TENNESSEE VALLEY AUTHORITY

Please refer to Thomas M. Novak's letter to H. G. Parris dated December 11, 1984 which transmitted the final draft version of the Watts Bar Nuclear Plant (WBN) unit 1 Appendix A Technical Specifications.

TVA's review of the final draft version of the WBN unit 1 Technical Specifications is near completion. Enclosed are our proposed modifications as of to date. Additional proposed changes will be forwarded in the near future.

FIGURE 2.1-1
 REACTOR CORE SAFETY LIMIT - FOUR LOOPS IN OPERATION

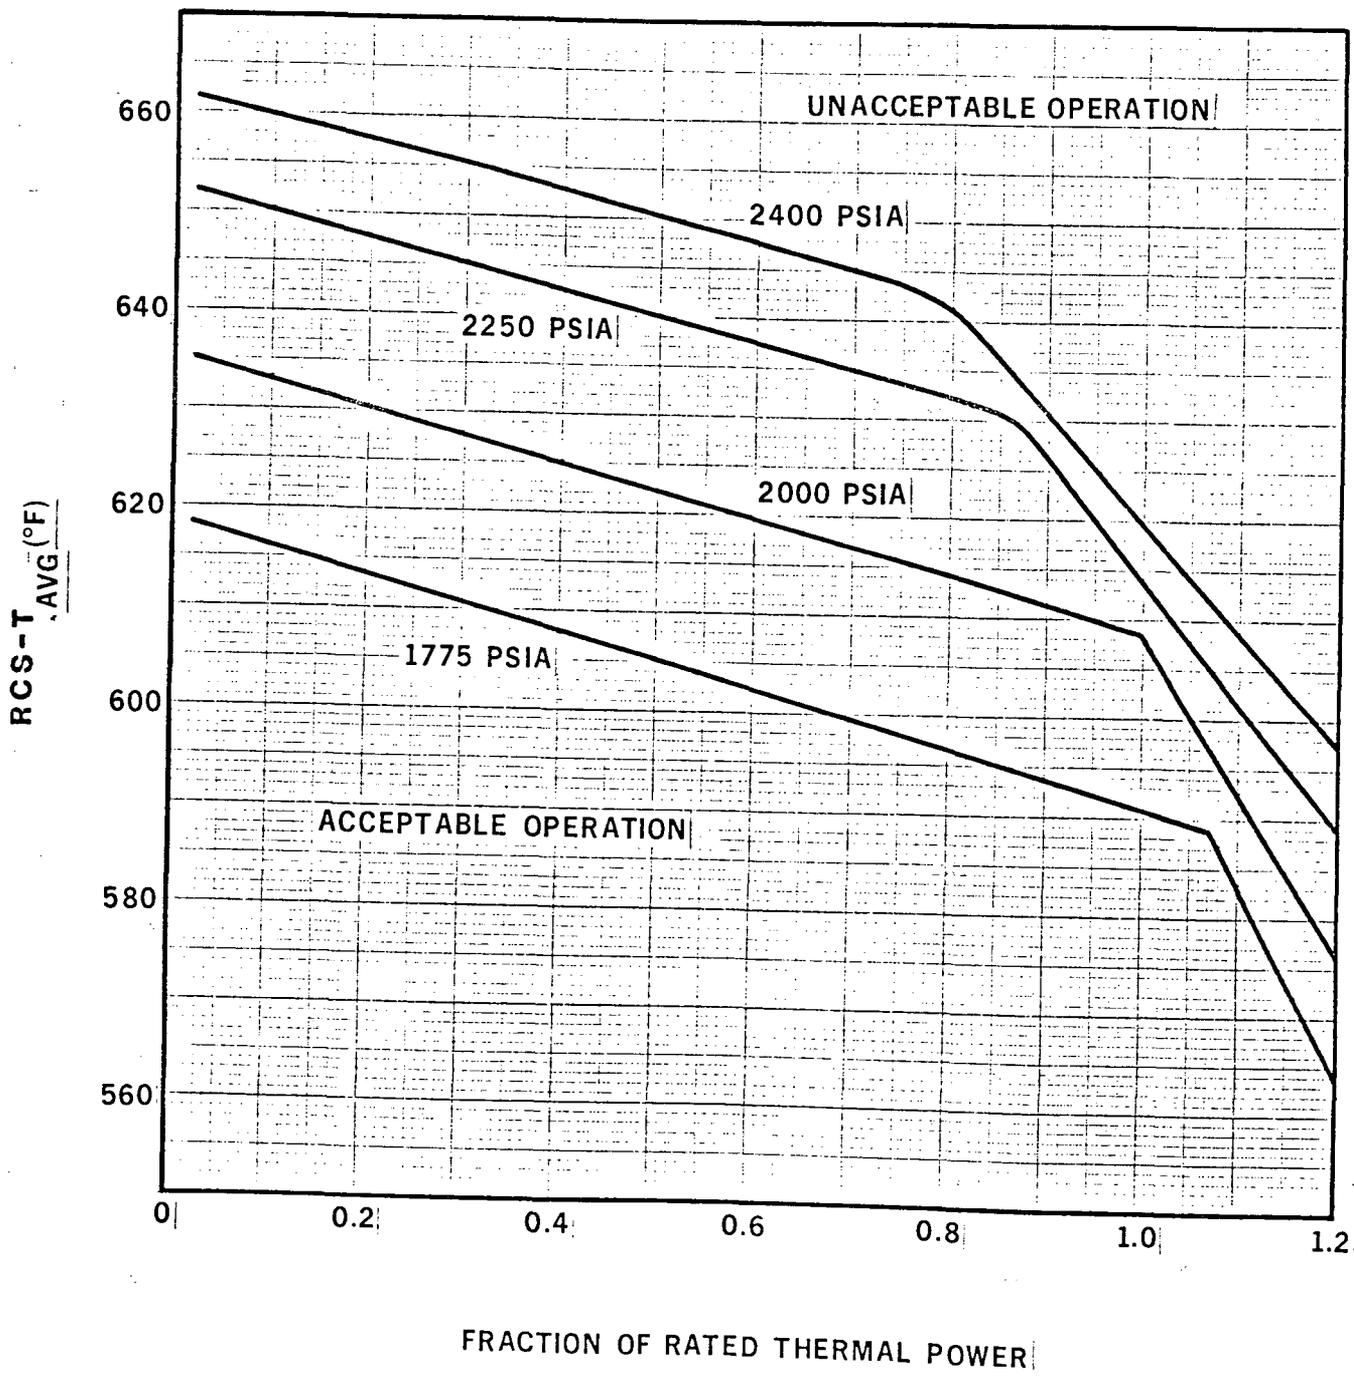
Figure 2.1-1 has been revised to reflect the reactor core safety limits for Watts Bar.

TABLE 3.3-1 (Continued)
REACTOR TRIP SYSTEM INSTRUMENTATION

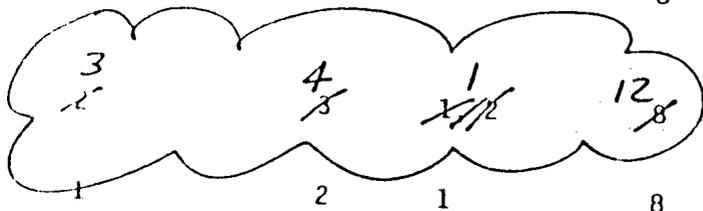
MINIMUM CHANNELS OPERABLE should be 4, not 3. Three channels are required to Auto Enable, thus 4 must be OPERABLE to meet single failure criteria. ACTION STATEMENT 12 has been added to reflect appropriate actions to different conditions. With less than 4 channels OPERABLE and the "Low Power" Reactor Trips blocked a plant shutdown below the P-10 setpoint (10 percent) is not warranted since the capability to enable the "Low Power" Reactor Trips may be lost. Since the P-10 bistables must be energized to enable the "Low Power" Reactor Trips, removing power from the bistables will not reinstate the trips. With less than 4 channels OPERABLE and the "Low Power" Reactor Trips not blocked, any P-10 failure will not block the "Low Power" Reactor Trips since it also takes coincident manual blocking (4 separate handswitches) to defeat them. Thus, the appropriate action is to restore the inoperable channels to OPERABLE status before blocking the "Low Power" Reactor Trip.
